TECHNICAL INFORMATION

TYPE NO IN/FB/ES 5100	TYPE Instant / Freshbrew / Espresso Machines	T.I.-NO ... 04/2002				
SERIAL NUMBERS AFFECTED From machine No 523633	ISSUED BY Documentation/ Wittenborg Odense					
SUBJECT New outlet holder	ISSUED FOR (X): <table border="1"> <tr> <td>Action</td> <td></td> </tr> <tr> <td>Information</td> <td>x</td> </tr> </table>		Action		Information	x
Action						
Information	x

The locking principle is that:

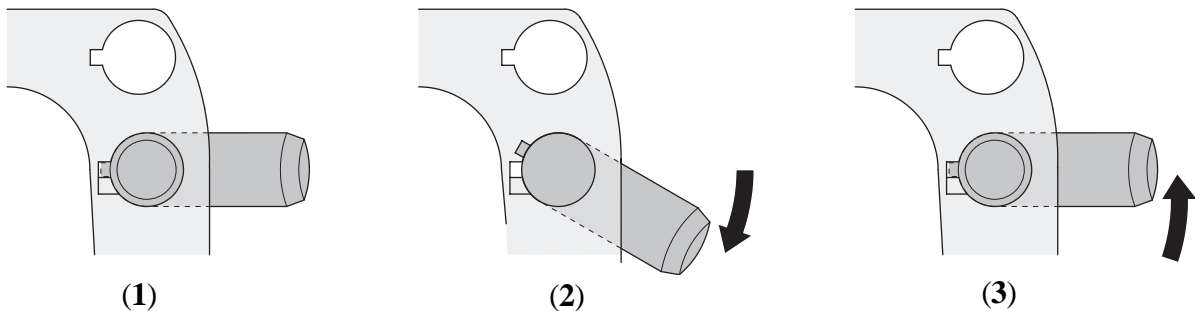
- From the above machine number the outlet tubes (short and long) in the machines have been supplied with a tab. Simultaneously the holder for outlet tubes (FB, IN and ES) have been provided with a notch and a tab.

- As the old type of outlet tubes could pop out of the holder for outlet tubes by accident, a kind of locking principle was requested.

- The notch in the holes of the holder for outlet tubes allows the tab of the outlet tubes to pass through the holder (1).
- The tab of the outlet tube locks the outlet tube to the holder, as the tube is turned (2).
- When the outlet tube is to be removed, it is turned until its tab is stopped by the position tap at the lower side of the holder. In this position the outlet tube is released and can be removed (3).
